UNITED STATES DEPARTMENT OF THE INTERIOR SOLUTION BUREAU OF LAND MANAGEMENT SUNDRY NOTICES AND REPORTS ON WELLS 5. Lease Serial No. NMNM125057

1. Type of Well			MAT	8. Well Name and No. EAST BLINEBRY I	DRINKARD LINIT 65			
Oil Well Gas Well Oth		DEECA FIGUED	RECE	O ADVANTA	SKIIVIONO OIVIT 03			
Name of Operator APACHE CORPORATION		REESA FISHER ner@apachecorp.com	REU	9. API Well No. 30-025-38760-00)-S1			
3a. Address 303 VETERANS AIRPARK LA MIDLAND, TX 79705	ANE SUITE 3000	3b. Phone No. (include are Ph: 432-818-1062	ea code)	10. Field and Pool or E EUNICE	xploratory Area

East Blinebry Drinkard Unit 65 30-025-38760 Apache Corporation Conditions of Approval

Permanent Abandonment of Production Zone Conditions of Approval

Schematic - Current

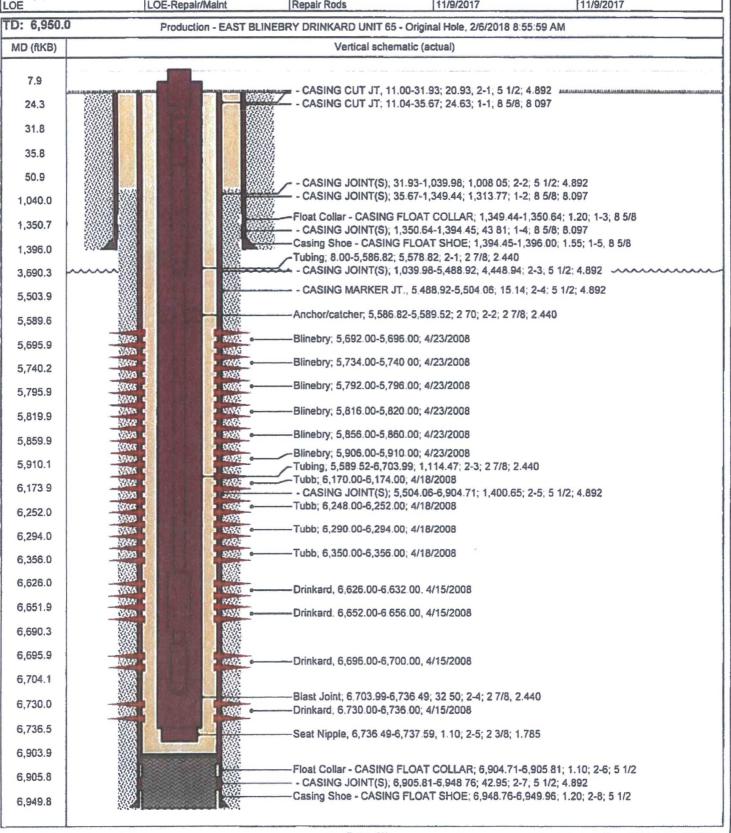
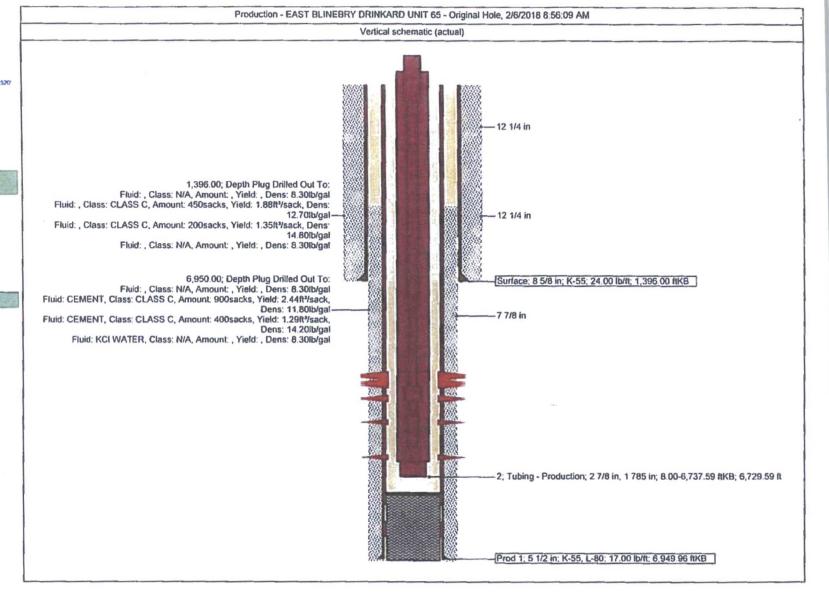
13. Describe Proposed or Completed Ope If the proposal is to deepen directions Attach the Bond under which the wor following completion of the involved testing has been completed. Final Ab determined that the site is ready for final	ally or recomplete horizontally, rk will be performed or provide l operations. If the operation re pandonment Notices must be fil	give subsurface locations and the Bond No. on file with Bl sults in a multiple completion	I measured an LM/BIA. Req or recomplet	d true vertical depths of all pertine uired subsequent reports must be f ion in a new interval, a Form 3160	nt markers and zones. filed within 30 days -4 must be filed once			
Apache is requesting approva	I to perform a cleanout ar	nd work on this well, as	follows:					
 POH with production equip TIH with bit to clean out to Set a RBP above the existi Perforate new Blinebry pay Restimulate the entire Bline Pull RBP above the Tubb. Run production equipment 	PBTD. ing Tubb completion. r from 5758 to 6015. Exise ebry with acid.		SEE	ATTACHED FOR

- Must conduct a casing integrity test before perforating and fracturing. Submit results to BLM. The CIT is to be performed on the production casing to max treating pressure. Notify BLM if test fails.

- 7. A minimum of a 2000 (2M) BOP to be used. All blowout preventer (BOP) and related equipment (BOPE) shall comply with reasonable well control requirements. A two ram system with a blind ram and a pipe ram designed for the size of the work string shall be adequate. Tapered work strings will require an additional pipe ram. The manifold shall comply with Onshore Oil and Gas Order #2 Attachment I (2M Diagrams of Choke Manifold Equipment). The accumulator system shall have an immediately available power source to close the rams and retain 200 psi above pre-charge. The pre-charge test shall follow requirements in Onshore Order #2.
- 8. Subsequent sundry required detailing work done, a C-102 form, and completion report for the new formations. Operator to include well bore schematic of current well condition when work is complete.
- 9. See attached for General Plugback Guidelines
